## New CLEI Label for Cisco 6260 PEMs

**July 10, 2000**

The CLEI code labels on one or more Cisco 6260 power entry modules (PEMs) at your site may contain an error. This package contains corrected replacement labels. This document tells you how to attach the label(s) to the hardware.

Figure 1 Applying the New CLEI Label

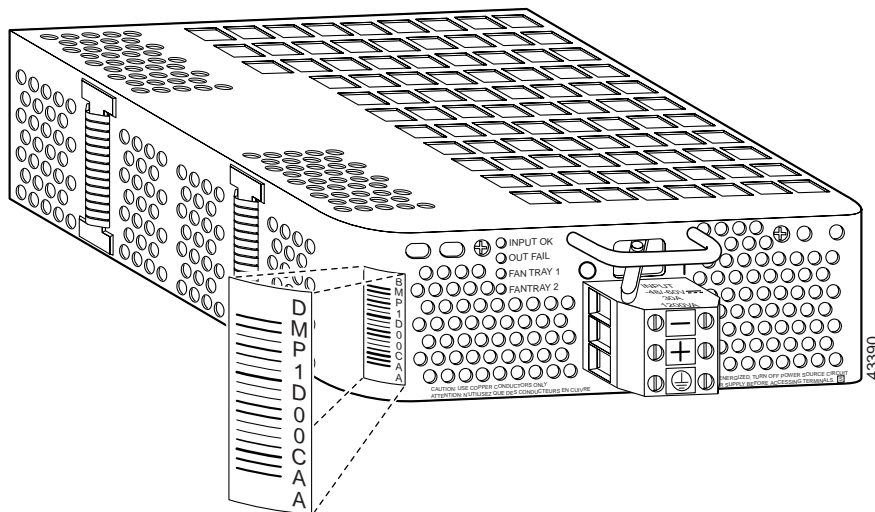
The error is found on Cisco 6260 PEMs shipped before June 1, 2000. On the affected CLEI labels, the first letter of the CLEI code is wrong:

Incorrect CLEI code    BMP1D00CAA

Correct CLEI code     DMP1D00CAA

- 
- Step 1**    Check the CLEI codes on all Cisco 6260 PEMs at your site. The PEMs are located at the bottom of the Cisco 6260 chassis, facing forward. The CLEI label is located on the front left corner of each PEM.
- Step 2**    Attach a new CLEI label to any PEM whose CLEI label is incorrect. Apply the new label so that it covers the old one. See [Figure 1](#).
-
